# UNITED STATES PATENT AND TRADEMARK OFFICE

10/585,439

## Office Action Summary

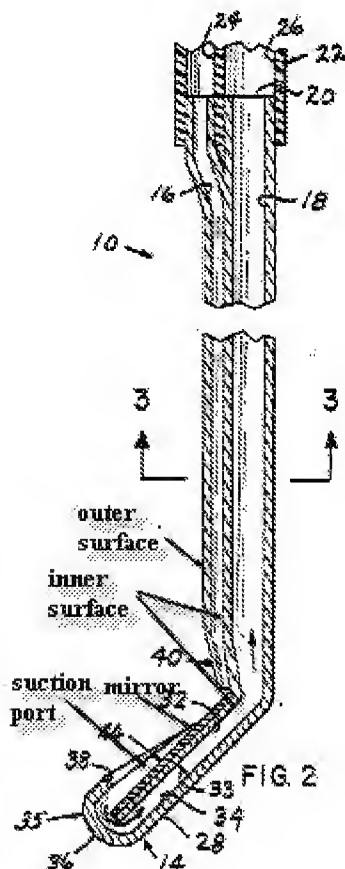
Claims 1, 2, 4, 5 are rejected under 35 U.S.C. 102(b) as being anticipated by Warriner (3,092,910).

Warriner discloses a dental suction apparatus (figures 1-5) having a hollow base body (e.g. 10) with a longitudinal axis X-X that comprises an outer surface (shown above), an inner surface (shown above) and a suction port (shown above), wherein a mirrored surface (shown above) is disposed in the region on the inner surface of the body. Please note that no suction or vacuum pump is attached to dental suction apparatus of claim 1 to perform any suctioning function.

Regarding claim 2, the inner surface has the mirrored surface (e.g. 44) that is viewable through the suction port, the suction port being configured to be at an incline (figure 2; col. 2, lines 21-23) with respect to the longitudinal axis X-X that the area of the suction port exceeds a cross-sectional area of the base body extending across the longitudinal axis.

Regarding claim 4, the mirror surface is disposed on a pluggable element (e.g. ring 54) that is releasably connected to the suction apparatus (col. 2, lines 60-65).

Regarding claim 5 a groove (e.g. recess 52) for insertion of the pluggable element is disposed in the region of the suction port (col. 2, lines 60-65).
